# City of Hurricane

## AGENDA

### OF A MEETING OF THE HURRICANE CITY PLANNING COMMISSION

Thursday, December 12, 2019

### JUC Comments:

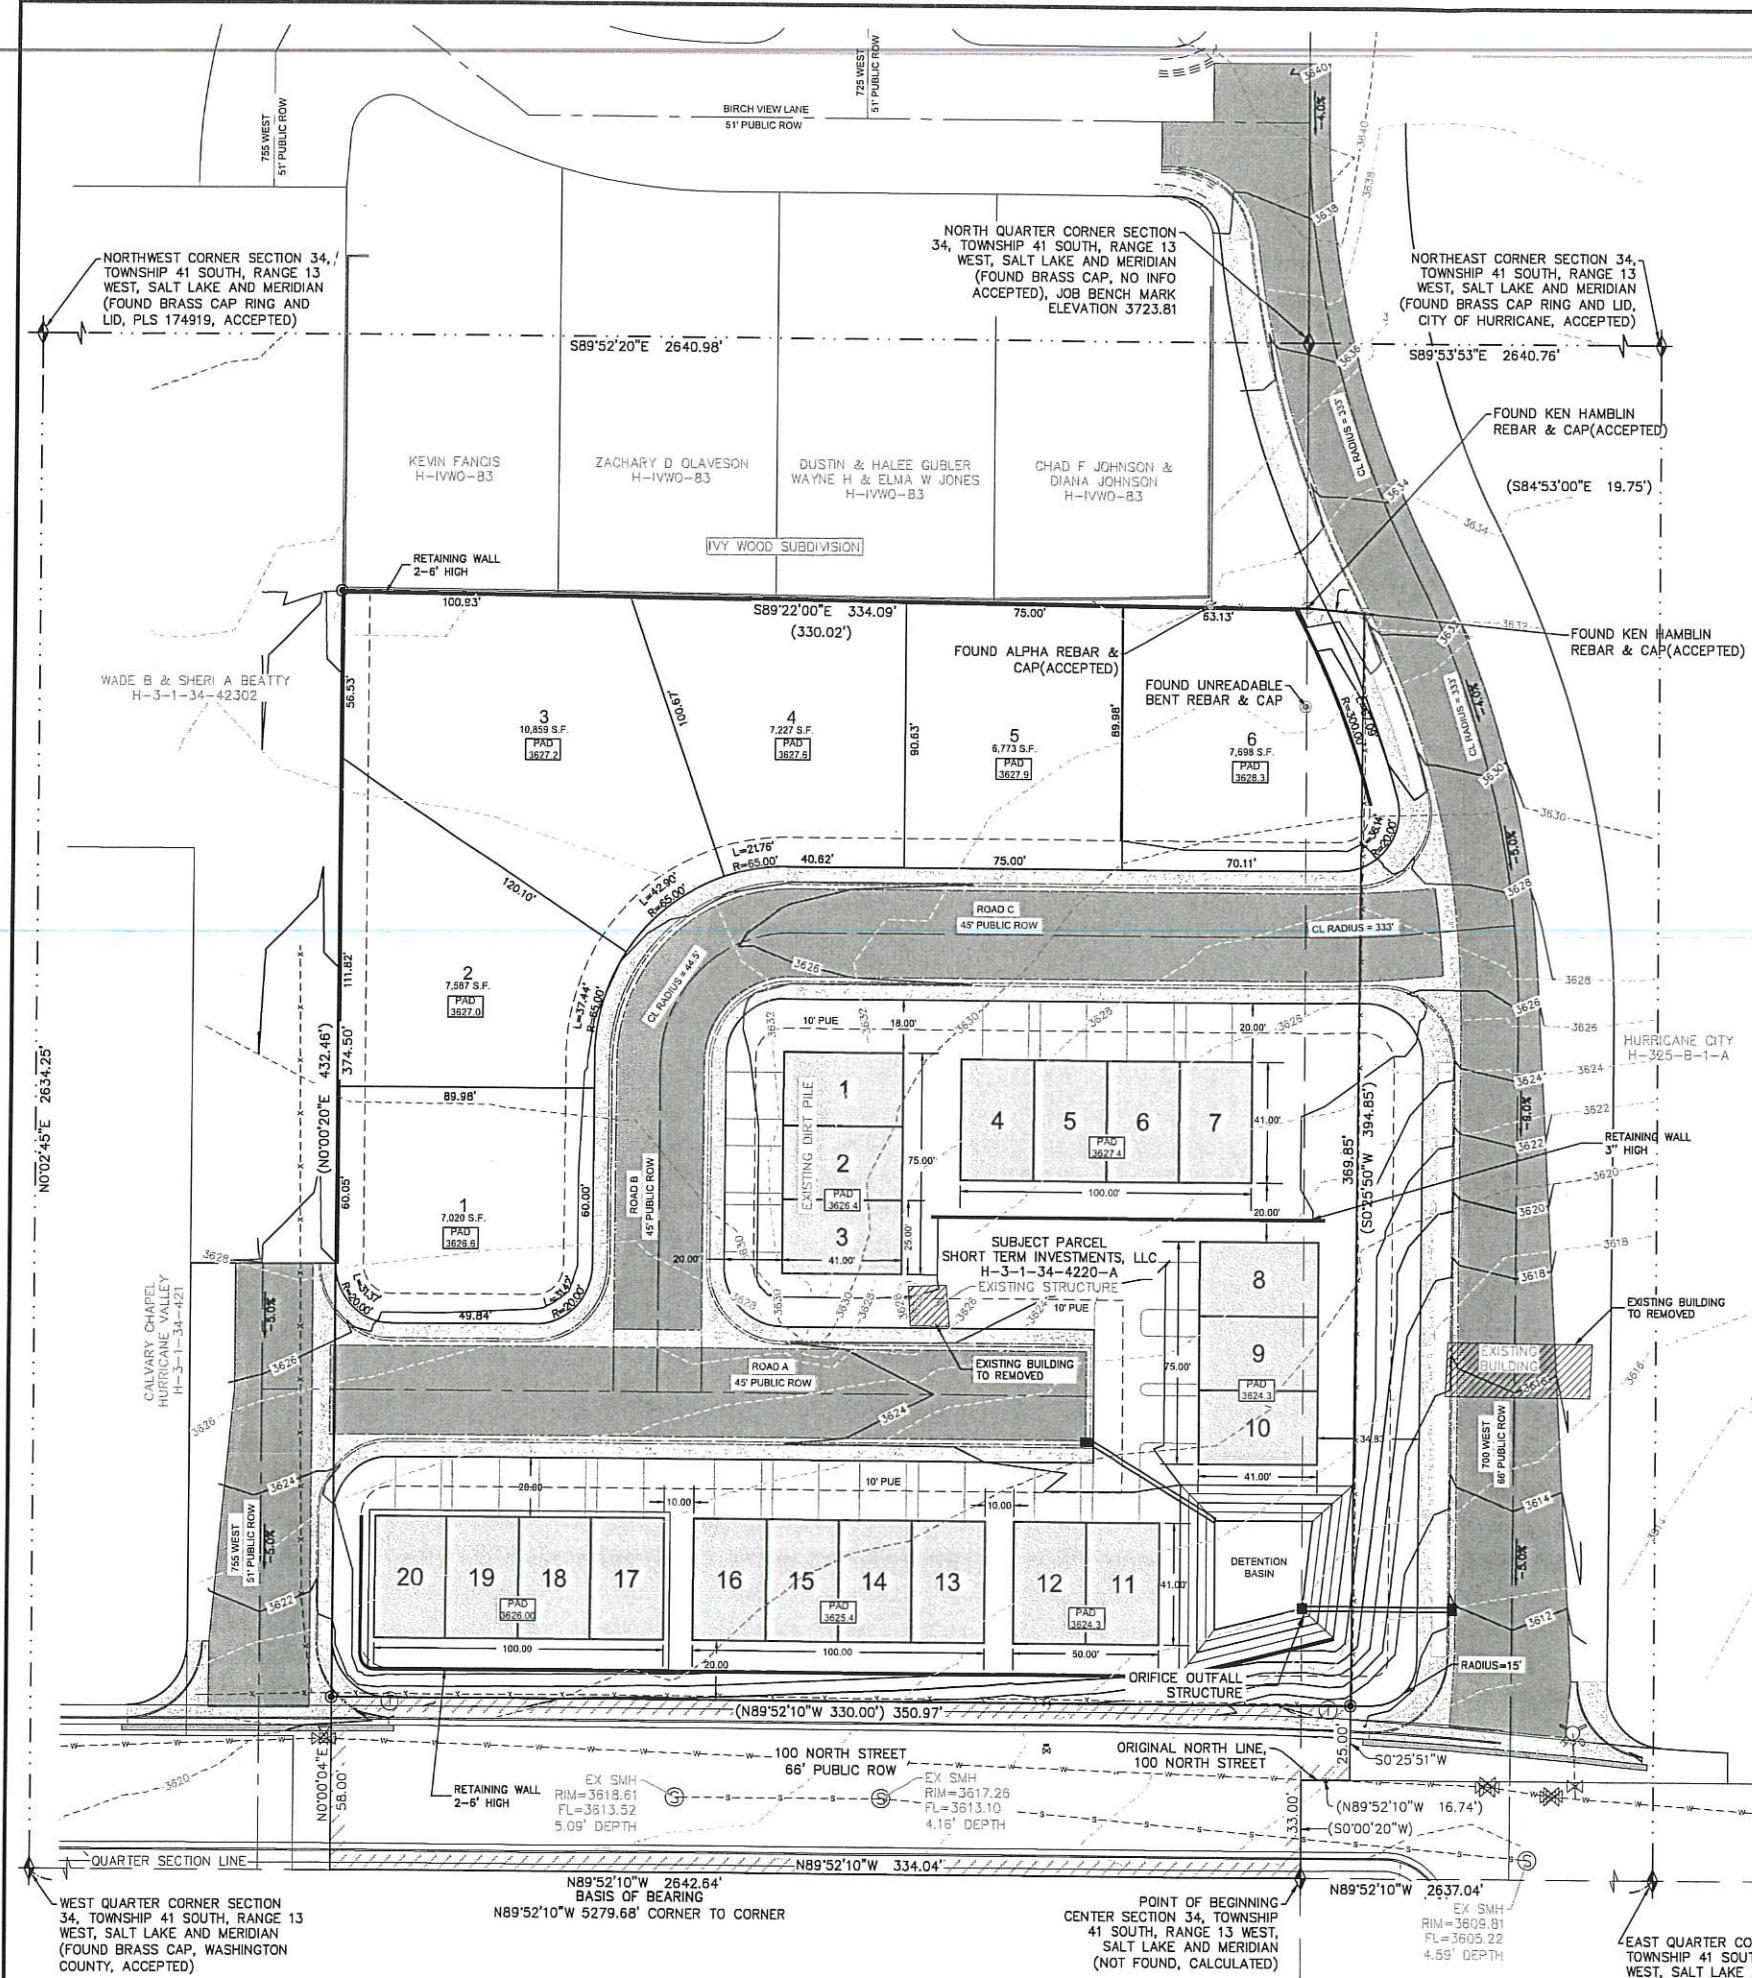
1. The tentative plan for storm water drainage shows a detention basin in the southeast corner of the project. Engineering is concerned the intersection of 100 North and 700 West may require construction of a round-about and property included in this structure may be needed. Consult with Engineering.
2. Sewer design will be required.
3. Improvements on 755 West will be required the full length of the road.

4. Secondary Water is available to the property and the system to serve individual properties must be included in the project improvements. Credit on fees will be given for the existing 2" secondary connection.
5. The 30" Hurricane Canal Company water line along the east of the property must be shown. Agreement and coordination with the Canal Company is required during construction drawing phase.
6. Water must loop between 100 North and 700 West.
7. Individual culinary water meters are required. Individual secondary connections are required on single family lots. Common areas may be served by a common secondary connection.
